## WATER LICENCE INSPECTION FORM

Licensee Re			Licensee Represer	see Representative			
Auryn Resources Rob L'Heure							
Licence No. / Expiry	Γitle						
	2BE-CRA1520						
Land / Other Authorizations			Land / Other Auth				
N2014C0002, N2014C00	005			, 056J/12-1-2			
Date of Inspection			Inspector				
26-27/06/2017			Eva Paul				
Activities Inspected  ☐ Camp ☐ Roads/Hauling ☐ Oth	ling er: Quarry	☐ Mining ☐ Construction ☐ Reclamation ☐ Fuel Storage ☐ Other:			∑ Fuel Storage		
Conditions: A- A	cceptable	U-Unacceptable	C-Concern	NI-Not Inspe	cted NA-	Not applicable	
PART:				Item No.*	Condition	Observation No.*	
A: SCOPE, DEFINITIONS AND	ENFORCEME	NT			А		
B: GENERAL CONDITIONS				B.6,8	U	1	
B: GENERAL CONDITIONS				B.9	U	2	
C: CONDITIONS APPLYING TO WATER USE					А		
D: CONDITIONS APPLYING TO WASTE DISPOSAL				B.11,12,13	А	3	
D: CONDITIONS APPLYING TO WASTE DISPOSAL				B.14	С	4	
E: CONDITIONS FOR CAMPS, ACCESS INFRASTRUCTURES AND OPERATIONS				E.2,6	С	5

A compliance inspection was conducted between 26 June and 28 June for Auryn's Committee Bay Project. Hayes, Bullion, and Crater camps, drilling activities, quarries, reclamation activities, fuel and waste management were all inspe

PHOTO LOG

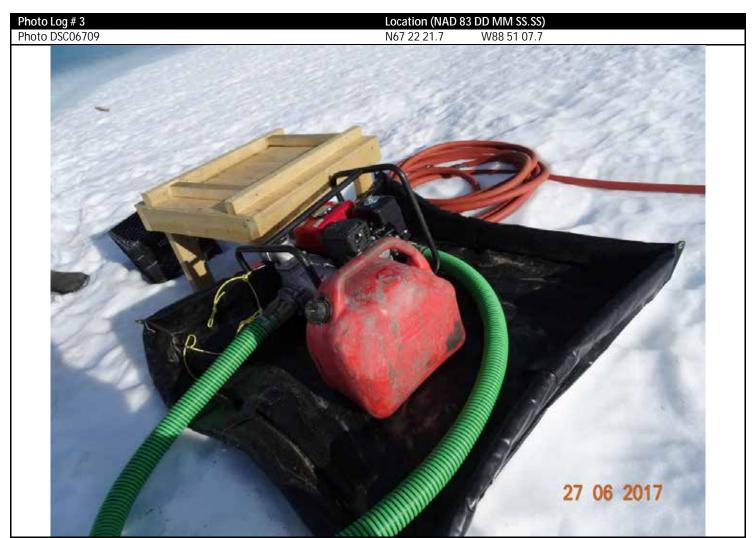
- 7. At Crater Camp, there was a jerry can of fuel in a small berm, perched on the snow margin of the lake. The berm is too

close, and could easily slip or move, allowing the jerry can to fall into the lake.

**Description**: Small spill tray with jerry can by Crater Lake. The fuel is to be stored on solid ground more than 30 m from the lake.

- F. Reportable spills are to be reported both to the Spill Line and directly to the Inspector as per item H.4.c.
- G. Fuel for the water intake pump should be kept on land, >31m from the OHWM.
